SCI-823-10.13

PID No. 79977

SR 823 OVER LUCASVILLE MINFORD Rd (CR 28)

PRELIMINARY DESIGN REPORT SUBMITTAL

SETTLEMENT PLATFORM

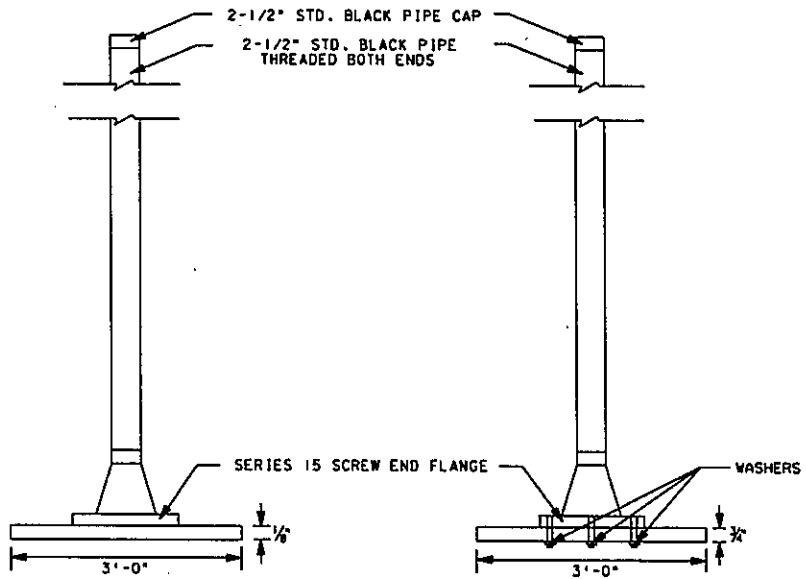
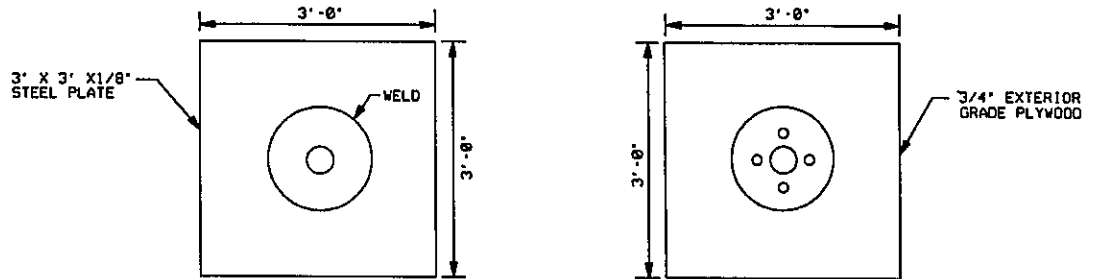
- 8) *Please include the following note in the plans.*

Settlement platform notes and details have been included.

SITE PLAN
 BRIDGE NO. SC1-823-1018 L
 SR 823 OVER LUCASVILLE-MINFORD ROAD (CR-28)

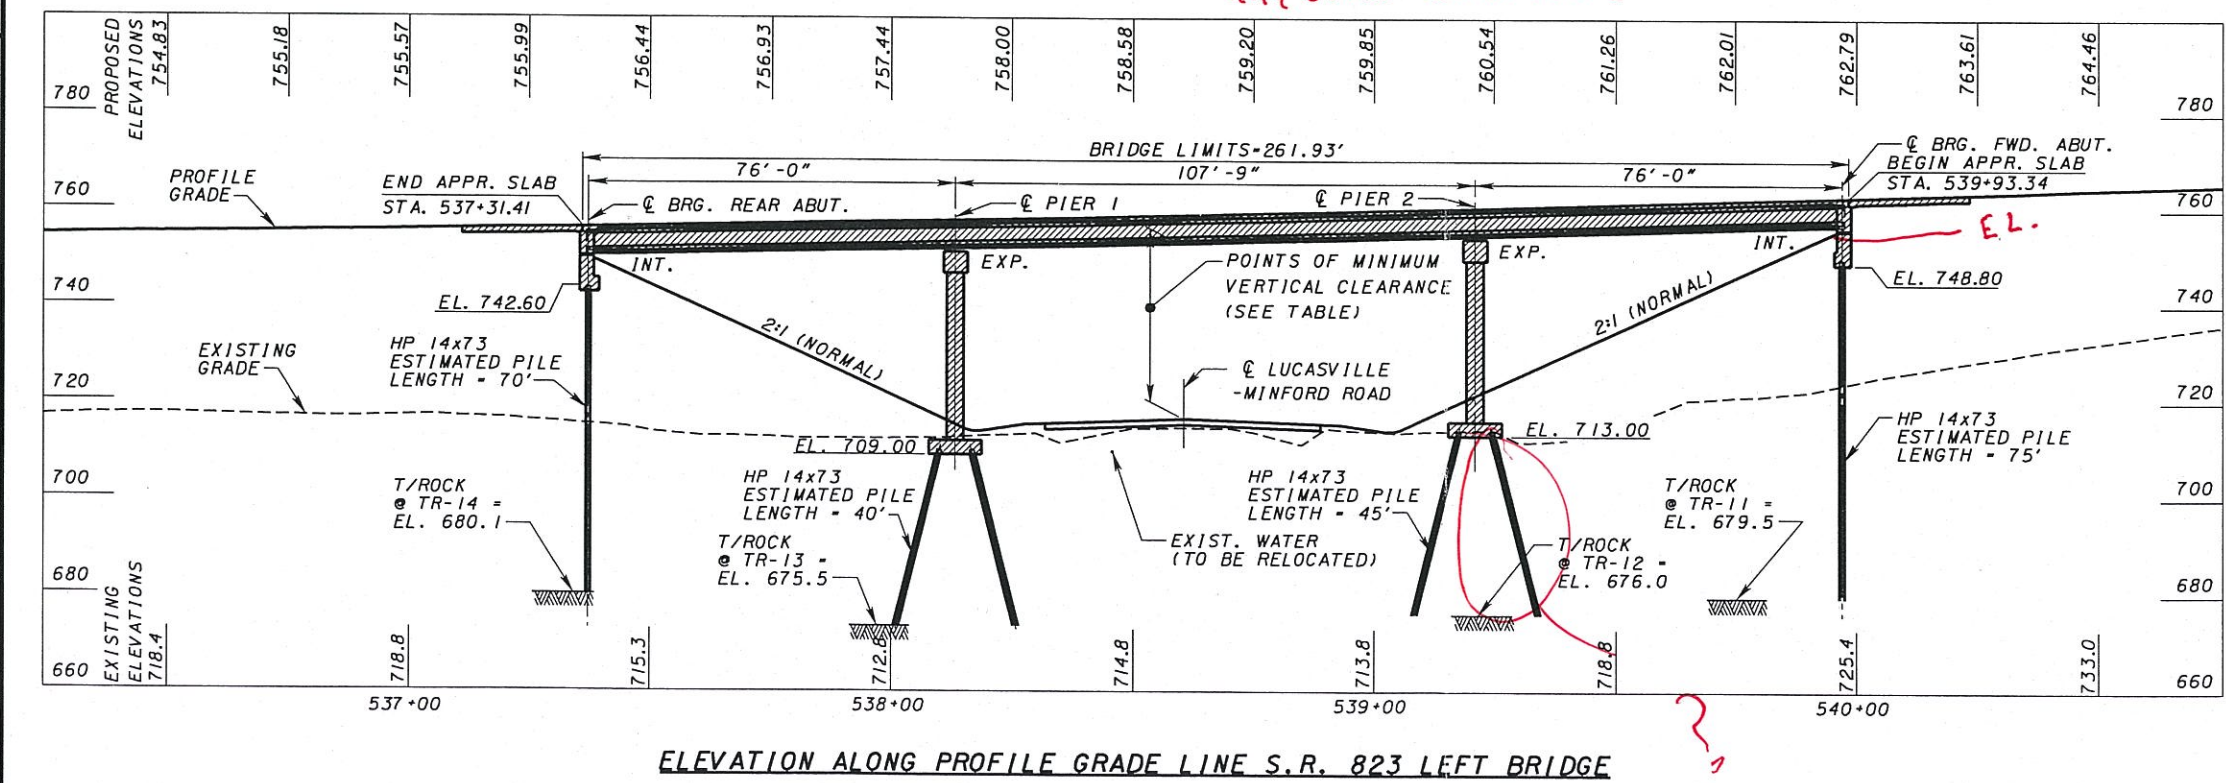
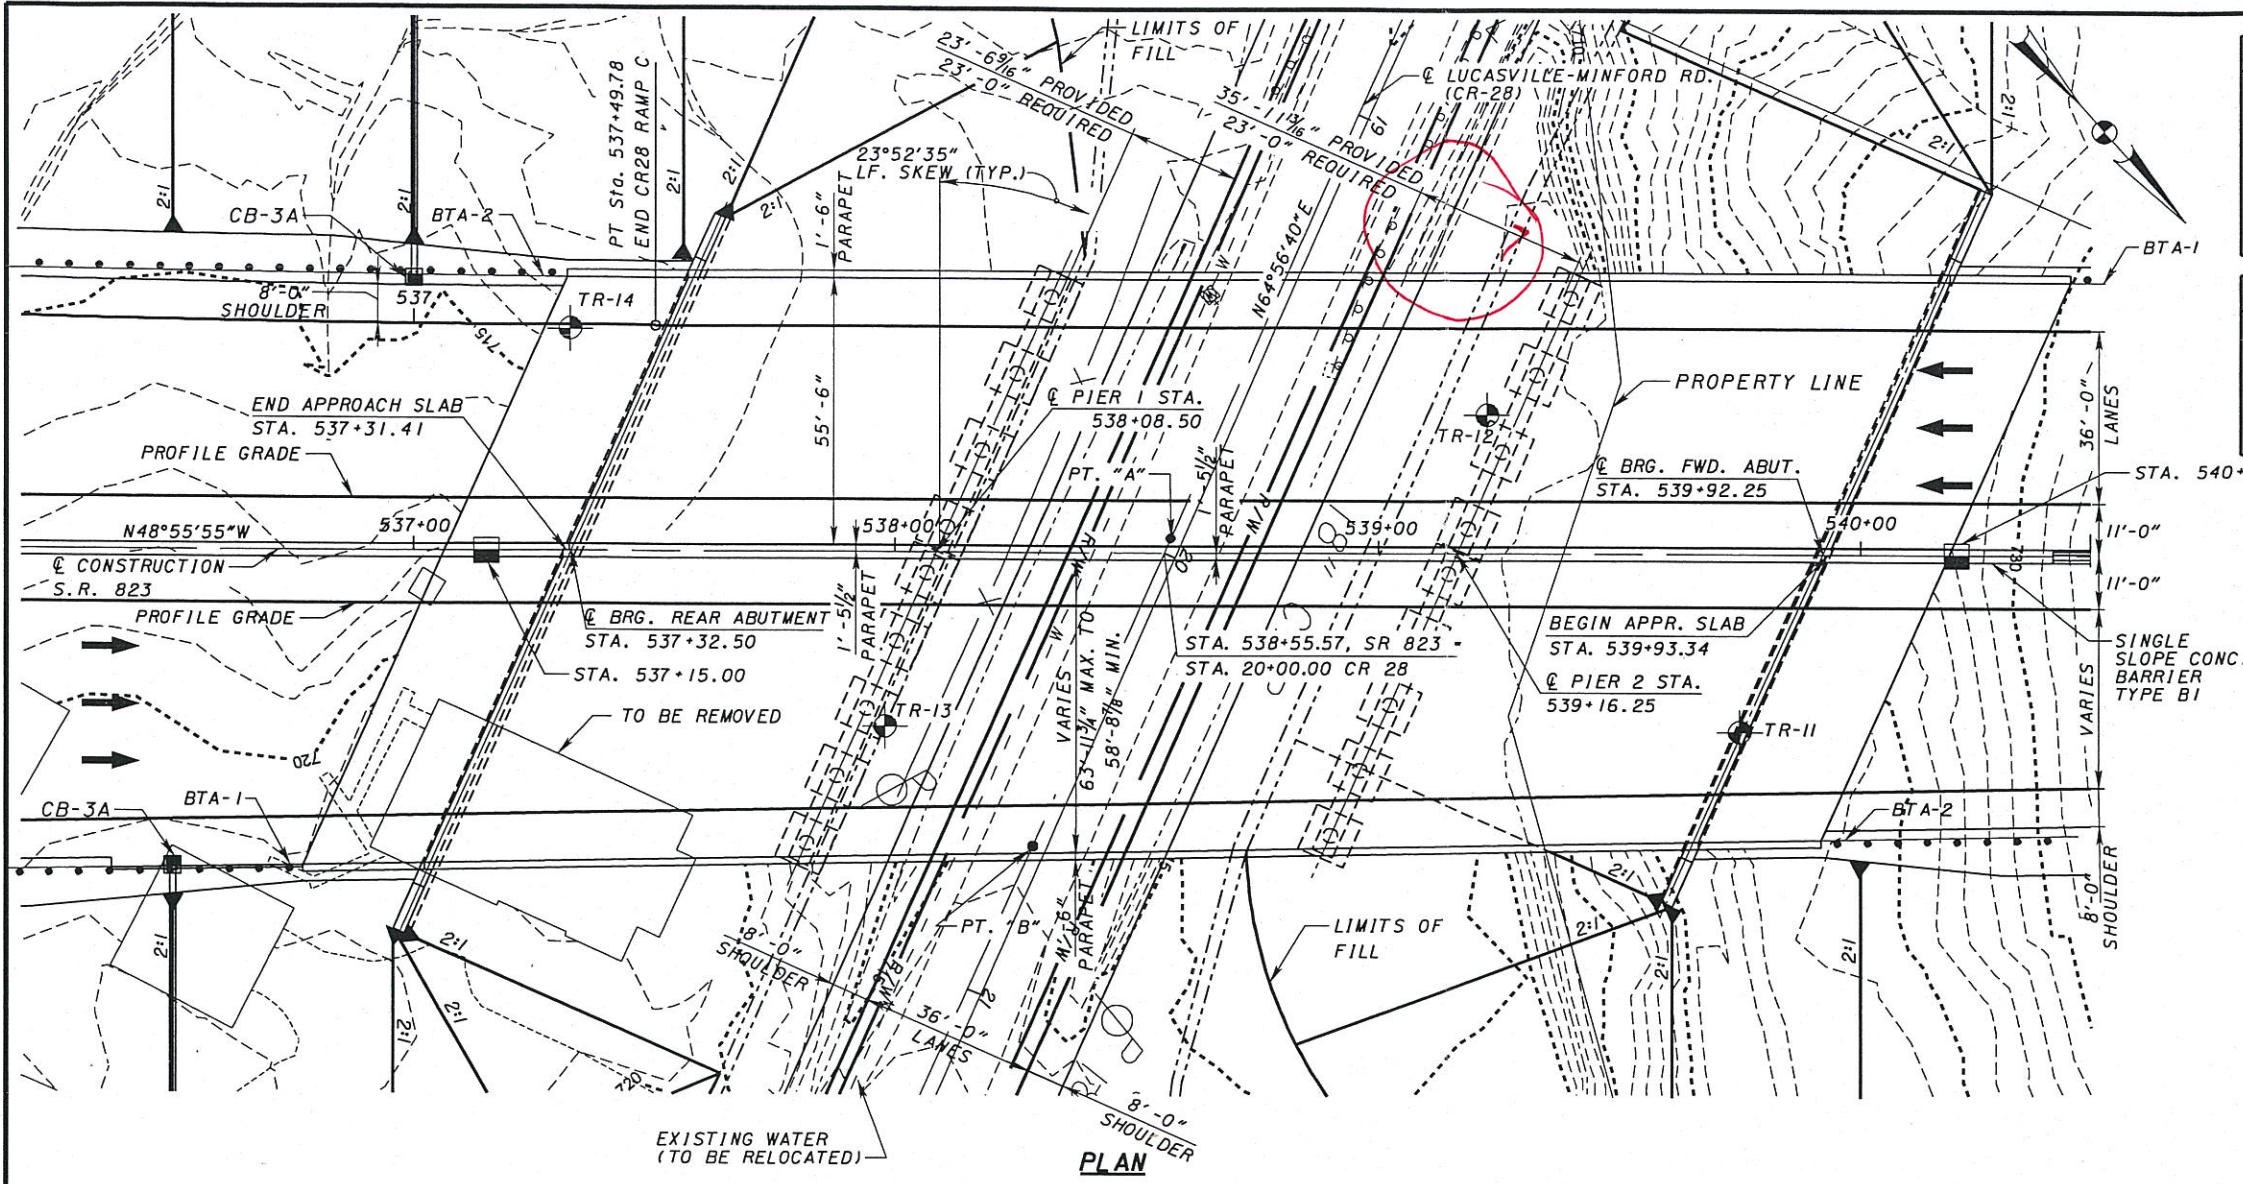
- 3) *Although, we would prefer the horizontal clearance shown to the pier column but in this case there should be a reference to the closest obstruction which is the toe of the slopes.*

- 5) *Show the profile grade on the site plan's Elevation View.*

The clearance to the toe of slope has been removed. The grading limits will be shown on the site plan however the roadway cross sections are the appropriate place to show the location of the toe of slope. The dimension was included at the STS since cross sections were not included with the submittal.

Will comply.
